Access Compliance Report Public Rights-of-Way (Curb Ramps)

Main Street: CLE GRANDE Cross Street: CHAPMAN_AVE Location: SE

ADA ID: RPAT210927090823 Ramp Type: Type 4 - Parallel Initial Pass/Fail: Fail Overall Compliance: No Severity Score: 19

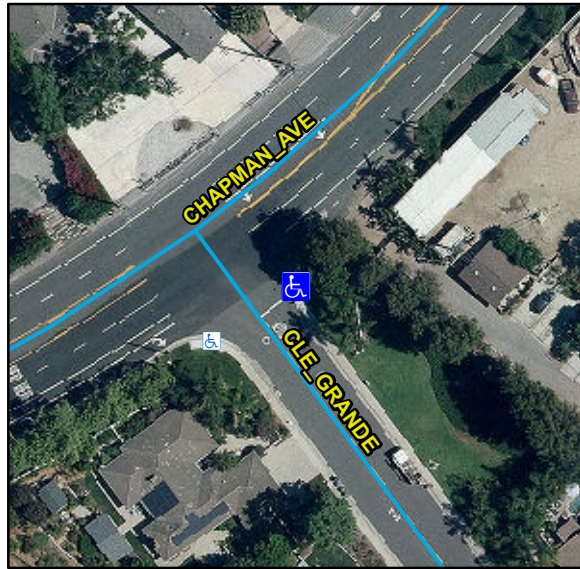
Compliance	Description	Data	Compliance	Description	Data
N/A	Ramp Length LT (in)	126	N/A	Ramp Length RT (in)	125
No	Ramp Width LT (in)	43	No	Ramp Width RT (in)	43
Yes	Ramp Run Slope LT (%)	2.3	No	Ramp Run Slope RT (%)	8.6
Yes	Ramp Cross Slope LT (%)	0.6	Yes	Ramp Cross Slope RT (%)	1.6
N/A	Landing Present	N/A	N/A	DWS Provided	N/A
N/A	Landing Length (in)	N/A	N/A	DWS Contrast	N/A
N/A	Landing Width (in)	N/A	N/A	DWS Length (in)	N/A
N/A	Landing Run Slope (%)	N/A	N/A	DWS Full Width	N/A
N/A	Landing Cross Slope (%)	N/A		DWS Offset Type	N/A
N/A	Landing Movement Obstructed?	N/A	N/A	DWS Offset Left (in)	N/A
	Landing Movement Type	N/A	N/A	DWS Offset Right (in)	N/A
N/A	Landing Shared	N/A			
N/A	Clear Space	N/A			
N/A	Clear Space To Crosswalk (in)	N/A			
N/A	Marked Crosswalk 1	No	N/A	Marked Crosswalk 2	N/A
	Crossing 1 Direction	W		Crossing 2 Direction	N/A
	Marked Crosswalk 1 Width (in)	N/A		Marked Crosswalk 2 Width (in)	N/A

Remove & Replace Entire Ramp.

R304.5.1, R304.3.2, STD 1115
